PHOENIX GOODYEAR AIRPORT NEW APRON AND TAXIWAY CONNECTOR DESIGN-BID-BUILD AV41000077 FAA/ADOT

ADDENDUM NO. 4

ISSUE DATE: April 5, 2023

o A2/CP501

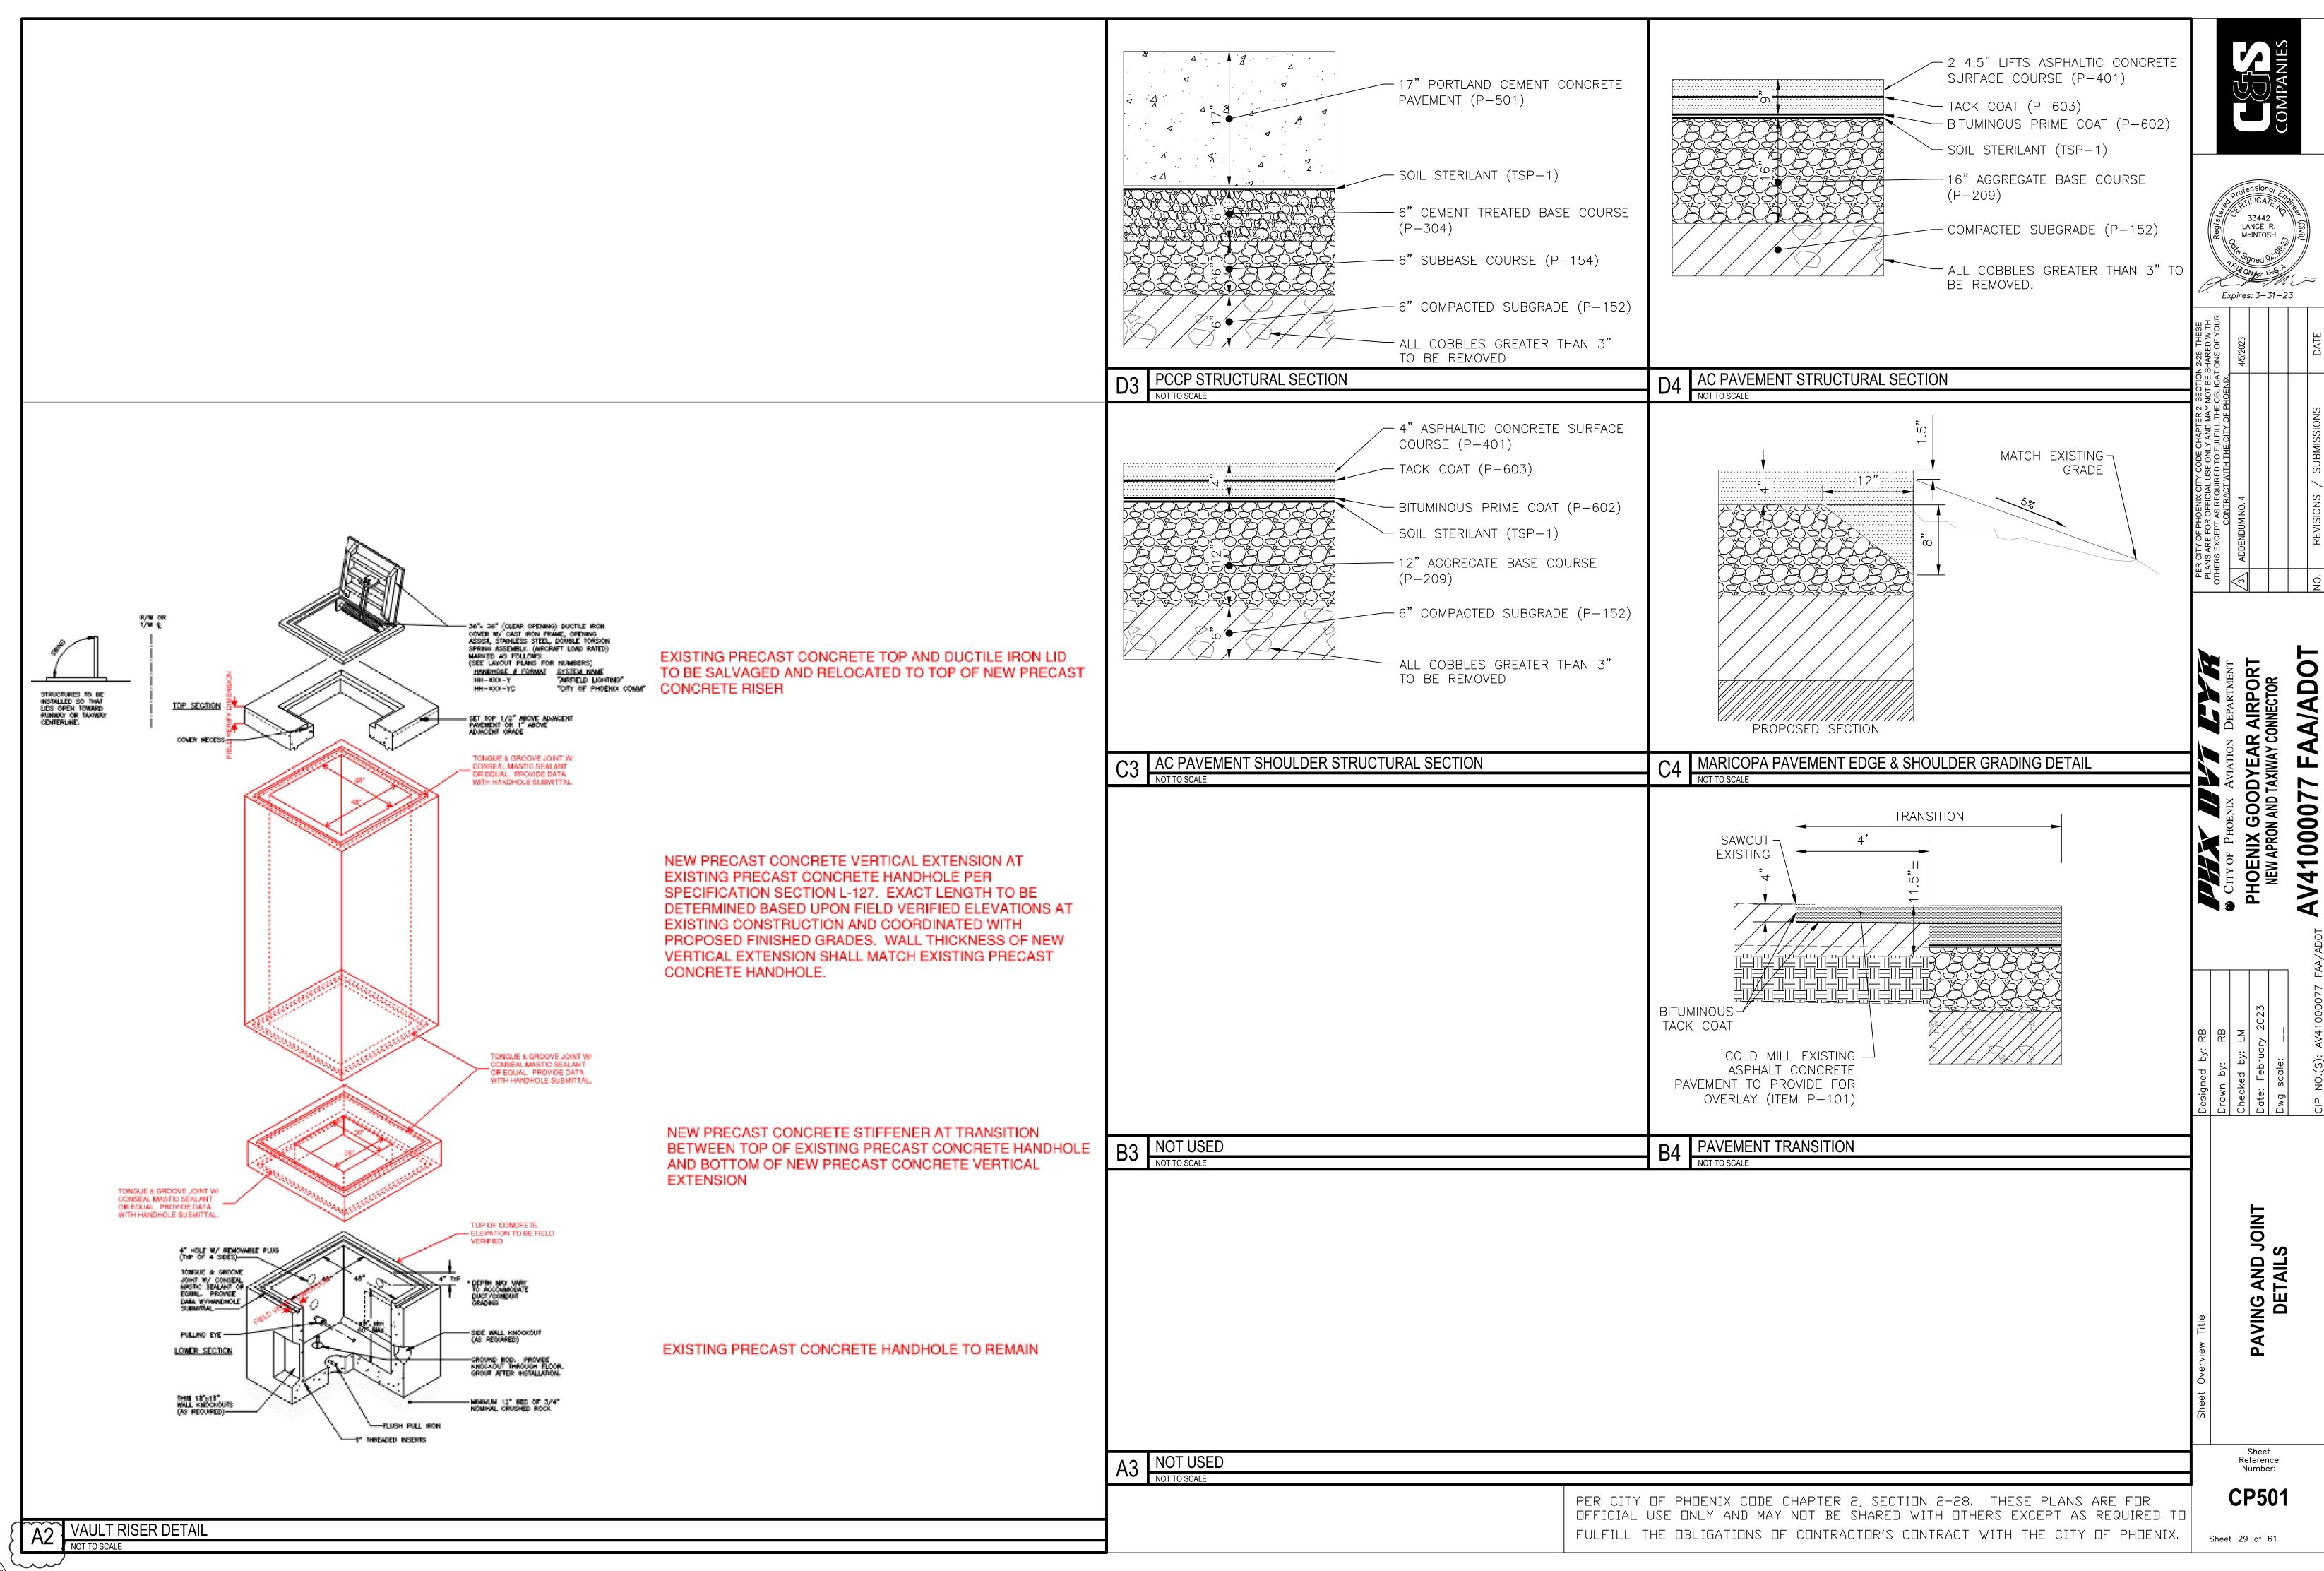
QUESTION 1: In reference to the existing well monitoring system, how are we supposed to figure out what system?

ANSWER: The project design intent is to not modify the existing monitoring well system but modify the existing concrete vault structure, so that the new vault elevation is accessible to the new apron grade per detail A1/CP501. The well system (underground pipes, valves)) should be protected in place and not modified.
